SERVICE LETTER 227

10000A Floats Inline Filters Replacement

Aircraft Makes/Model(s):	Float Model(s):	Compliance: Optional	By: MAB
Air Tractor	10000A	Part Number: 1011841	Approved: DRH
AT-802 & AT-802A		Date: 11/28/2022	Revision: B

FIGURE 1 - INLINE FILTERS AT ACCUMULATOR ASSEMBLY

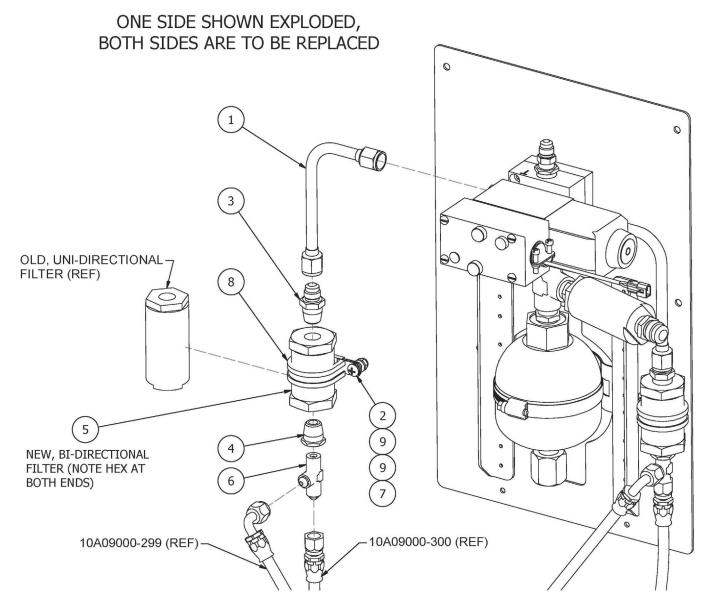
This service letter applies to Air Tractor models AT-802 & AT-802A with Wipline 10000 Amphibian Floats installed per STC SA01795CH which contain uni-directional inline filters between the scoop cylinders and the directional valve. Refer to Figure 1 to assess applicability.

When hydraulic fluid is returned from the scoop cylinders, it is causing the filter element to chatter against the internal o-ring. The o-ring can fail causing small pieces of o-ring to flow out of the inline filter and into the directional valve. This service letter provides installation instructions to replace the two inline filters from the scoops to the directional valve with bi-directional inline filters.

- 6. Remove 10A09000-299 and 10A09000-300 scoop hydraulic lines from MS20826-5D tee fittings (item 6).
- 7. Remove adel clamps (item 8) which hold the inline filters to the accumulator mount assembly by removing associated hardware (items 2, 9, 9, 7).

- 8. Disconnect the hard hydraulic lines (item 1) from inline filters and from directional valve, ports "A" and "B."
- 9. Install new fittings (items 3, 4, 6) into new bi-directional inline filters (item 5) per image. Use thread sealant with all pipe threads.

- 10. Install new hard hydraulic lines (item 1) onto new filter fittings (item 3). **Note:** Item 1 has been revised and may be longer than those previously installed.

- 11. Install other end of new hydraulic hard line assemblies (item 1) onto directional valve manifold fittings, ports "A" and "B."
- 12. Secure new bi-directional inline filters to accumulator mount with new adel clamps (item 8) and new hardware (items 2, 9, 9, 7).

- 13. Reinstall hydraulic lines 10A09000-299 and 10A09000-300 onto tee fittings (item 6).
- 14. Ensure gear selector handle is in the appropriate position, and re-engage pump 1 and pump 2 circuit breakers.

FIGURE 2 - HYDRAULIC SCOOP SCHEMATIC

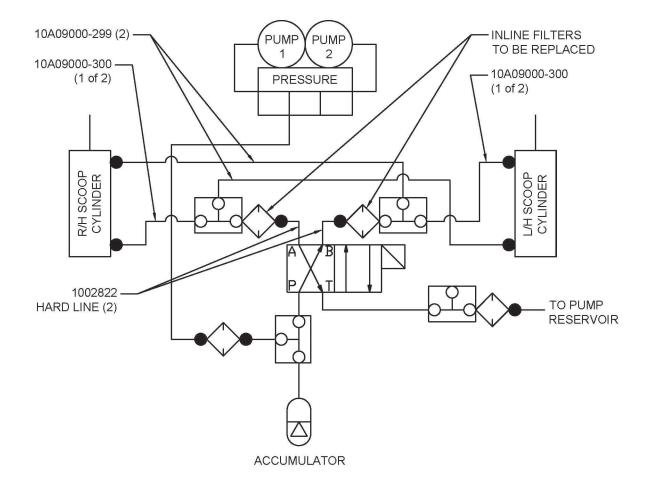
(REFER TO FIGURE 1 FOR STEPS 6-13. FIGURE 2 PROVIDES A SCHEMATIC REPRESENTATION.)
